SUBJECT: ISSUANCE OF AMENDMENTS (TAC NOS. M79900 AND 79901) (TS 90-01)

The Commission has issued the enclosed Amendment No. 158 to Facility Operating License No. DPR-77 and Amendment No. 148 to Facility Operating License No. DPR-79 for the Sequoyah Nuclear Plant, Units 1 and 2, respectively. These amendments are in response to your application dated March 1, 1991 and superseded by letter dated September 6, 1991.

The amendment incorporates new reactor coolant system pressure-temperature limit curves that are applicable up to 16 effective full power years.

SAFETY EVALUATION BY THE OFFICE OF NUCLEAR REACTOR REGULATION
RELATED TO AMENDMENT NO.158 TO FACILITY OPERATING LICENSE NO. DPR-77
AND AMENDMENT NO. 148 TO FACILITY OPERATING LICENSE NO. DPR-79

FIGURE 3.4-2 SEQUOYAH UNIT 1 REACTOR COOLANT SYSTEM HEATUP LIMITATIONS
 APPLICABLE UP TO 16 EFPY

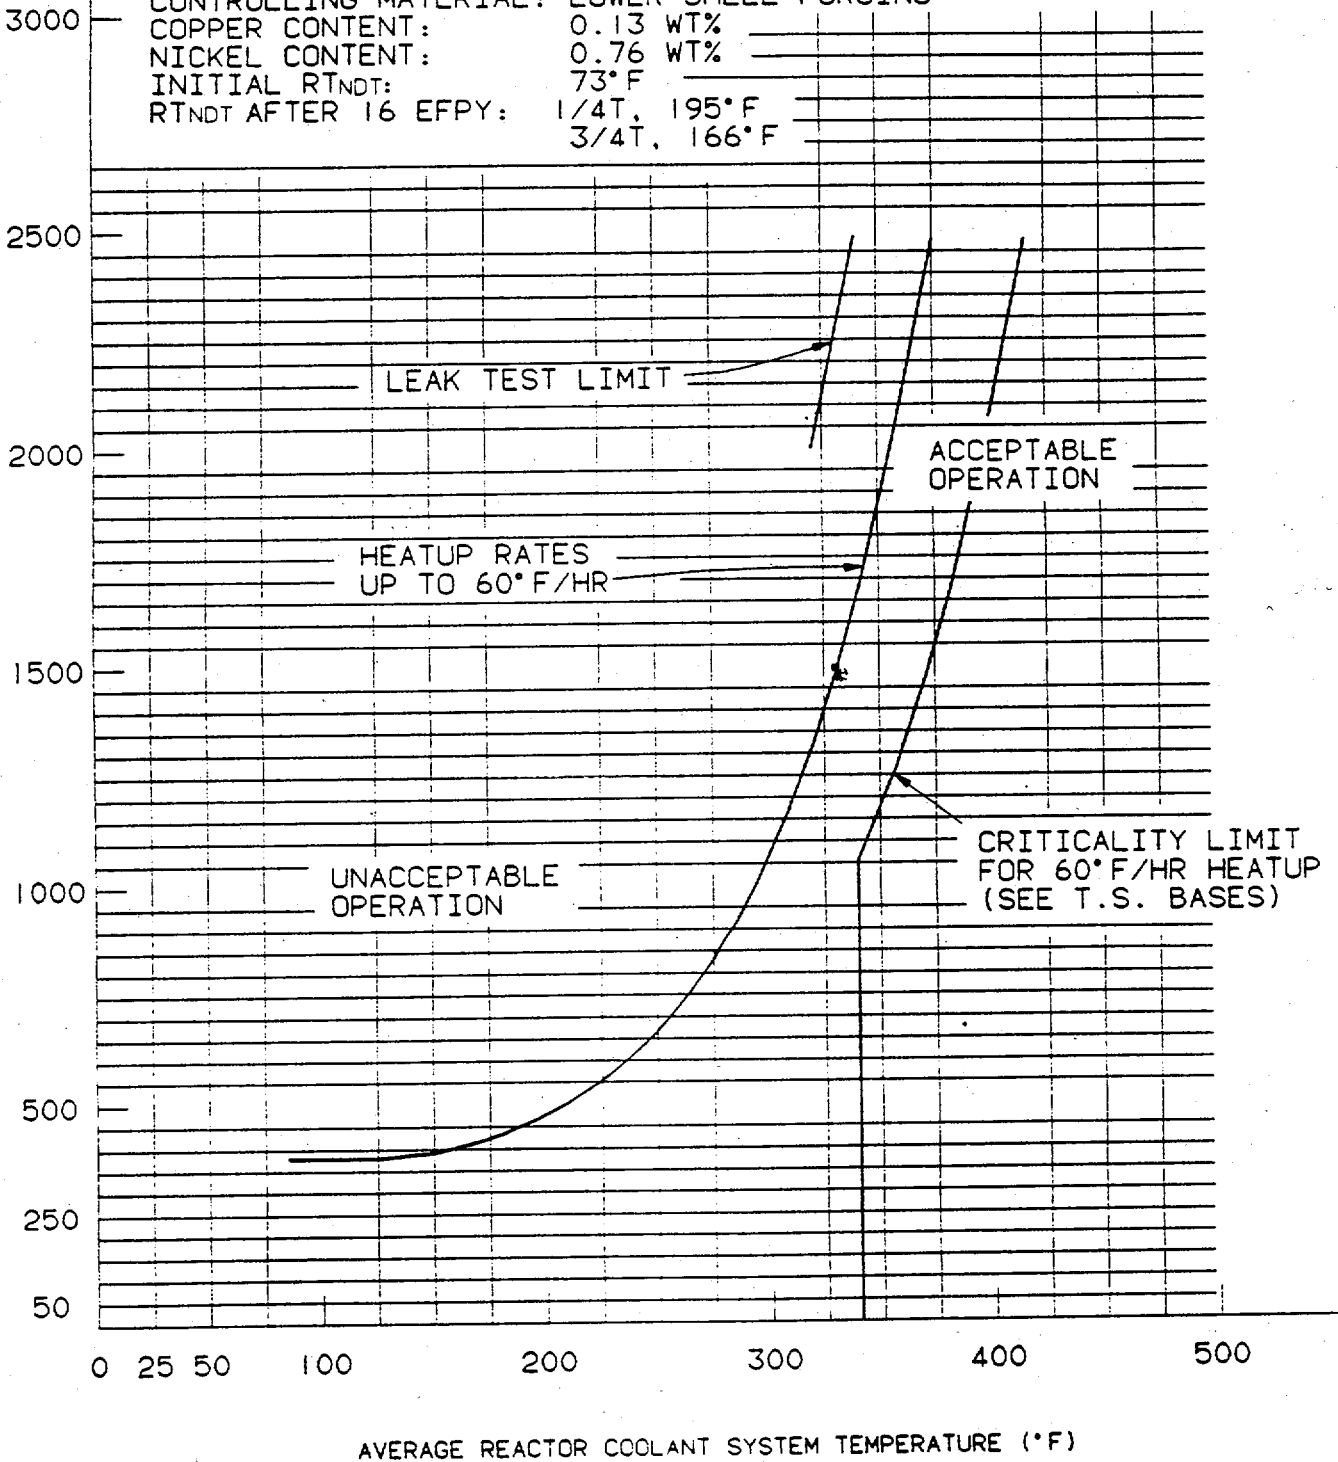
CURVES APPLICABLE FOR HEATUP RATES UP TO 60°F/HR
 FOR THE SERVICE PERIOD UP TO 16 EFPY. MARGINS OF 60 PSIG
 AND 10°F ARE INCLUDED FOR POSSIBLE INSTRUMENT ERROR.

MATERIAL PROPERTY BASIS - SON UNIT 1

CONTROLLING MATERIAL: LOWER SHELL FORGING

COPPER CONTENT: 0.13 WT%

NICKEL CONTENT: 0.76 WT%

INITIAL RT_{NDT}: 73°F

RT_{NDT} AFTER 16 EFPY: 1/4T, 195°F
 3/4T, 166°F

FIGURE 3.4-3 SEQUOYAH UNIT 1 REACTOR COOLANT SYSTEM COOLDOWN LIMITATIONS APPLICABLE UP TO 16 EFPY

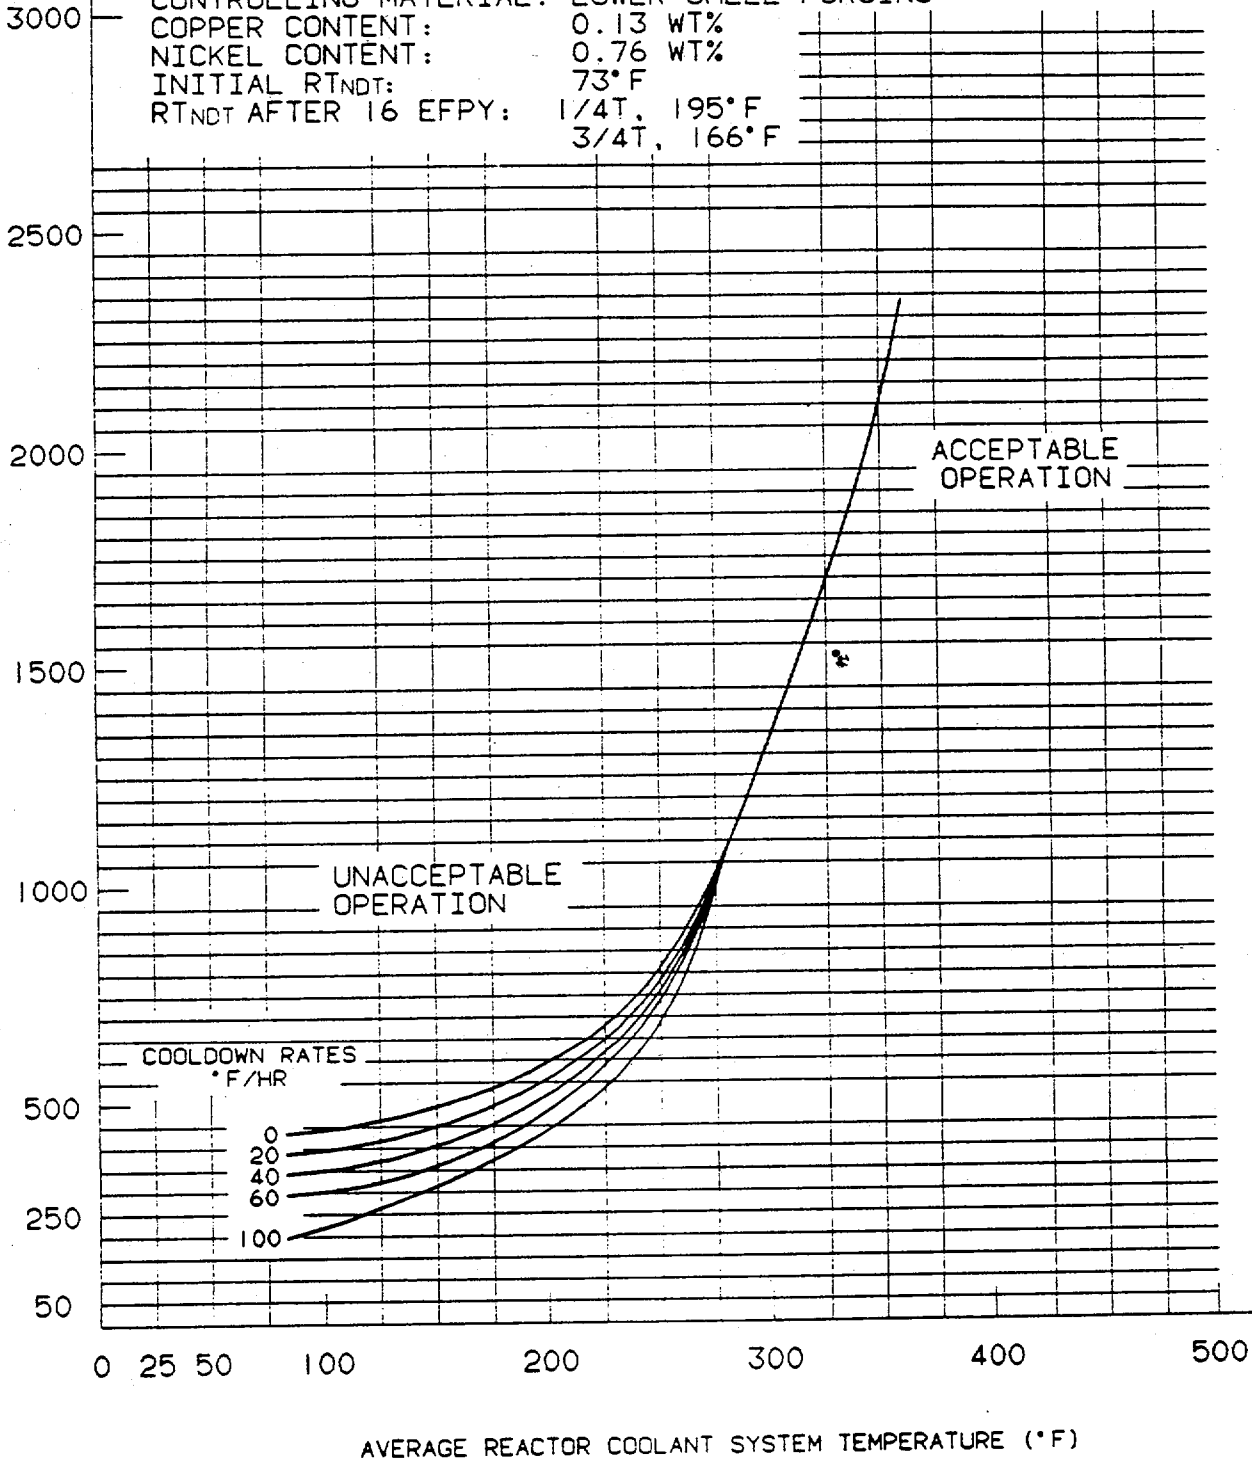
CURVES APPLICABLE FOR COOLDOWN RATES UP TO 100°F/HR FOR THE SERVICE PERIOD UP TO 16 EFPY. MARGINS OF 60 PSIG AND 10°F ARE INCLUDED FOR POSSIBLE INSTRUMENT ERROR.

MATERIAL PROPERTY BASIS - SQN UNIT 1

CONTROLLING MATERIAL: LOWER SHELL FORGING

COPPER CONTENT: 0.13 WT%

NICKEL CONTENT: 0.76 WT%

INITIAL RTNDT: 73°F

RTNDT AFTER 16 EFPY: 1/4T, 195°F
3/4T, 166°F

FIGURE 3.4-2 SEQUOYAH UNIT 2 REACTOR COOLANT SYSTEM HEATUP LIMITATIONS
 APPLICABLE UP TO 16 EFPY

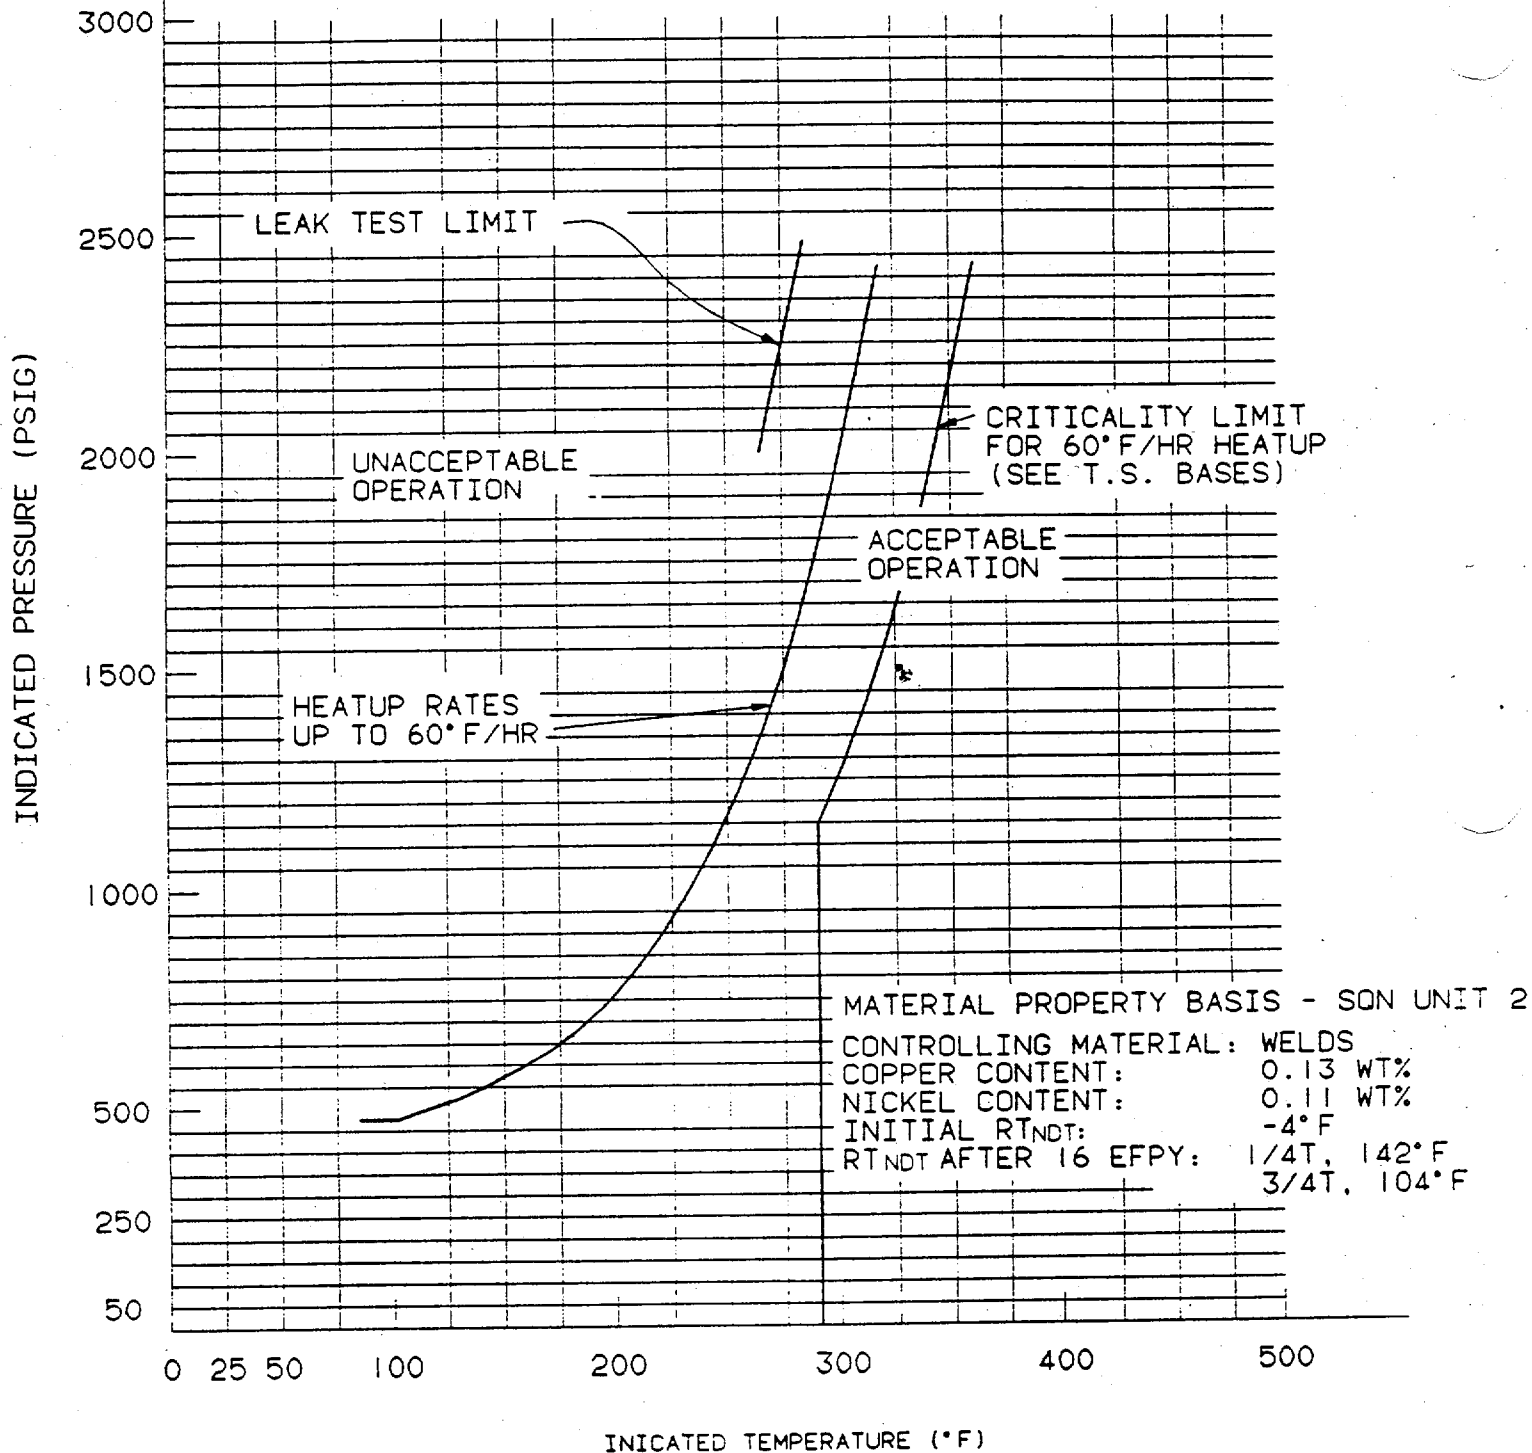
CURVES APPLICABLE FOR HEATUP RATES UP TO 60 F/HR
 FOR THE SERVICE PERIOD UP TO 16 EFPY. MARGINS OF 60 PSIG
 AND 10°F ARE INCLUDED FOR POSSIBLE INSTRUMENT ERRORS.

FIGURE 3.4-3 SEQUOYAH UNIT 2 REACTOR COOLANT SYSTEM COOLDOWN LIMITATIONS APPLICABLE UP TO 16 EFPY

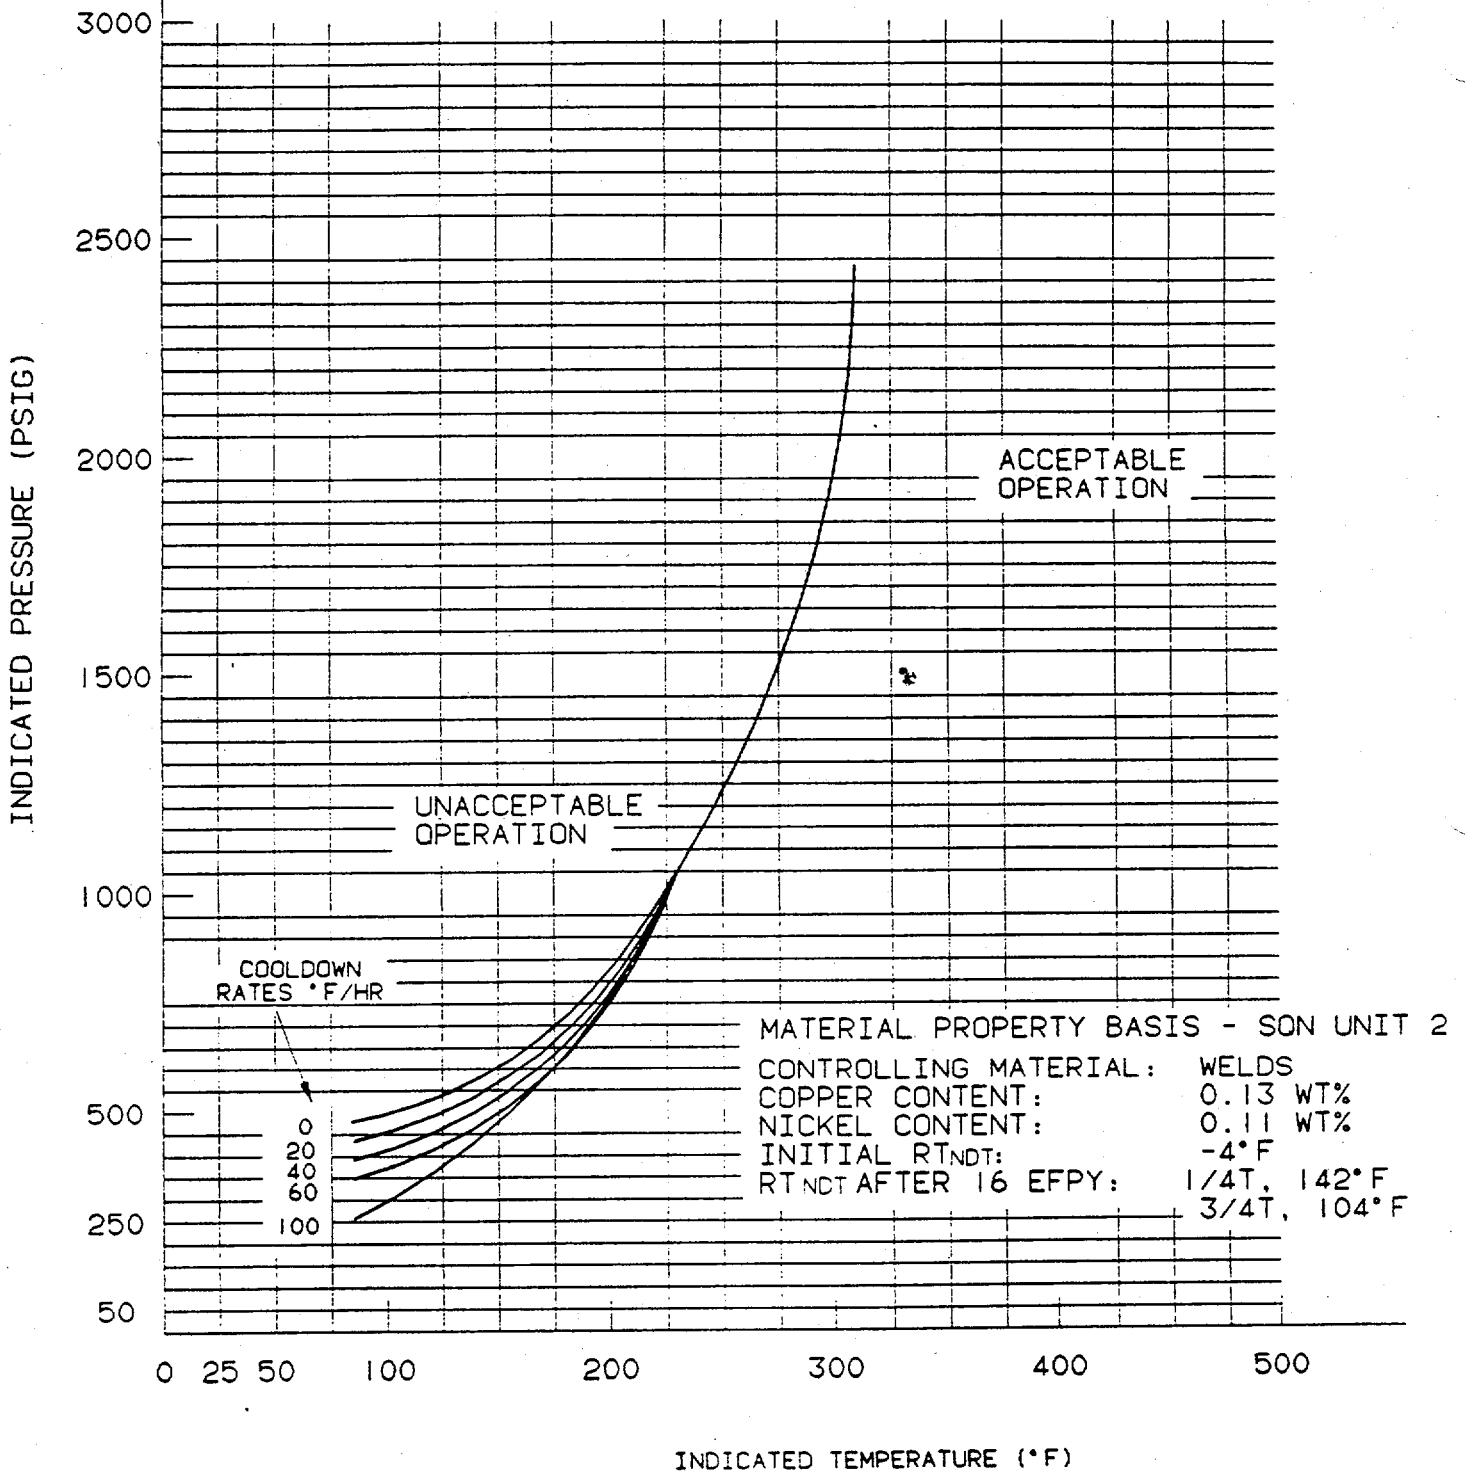
CURVES APPLICABLE FOR COOLDOWN RATES UP TO 100°F/HR FOR THE SERVICE PERIOD UP TO 16 EFPY. MARGINS OF 60 PSIG AND 10°F ARE INCLUDED FOR POSSIBLE INSTRUMENT ERRORS.
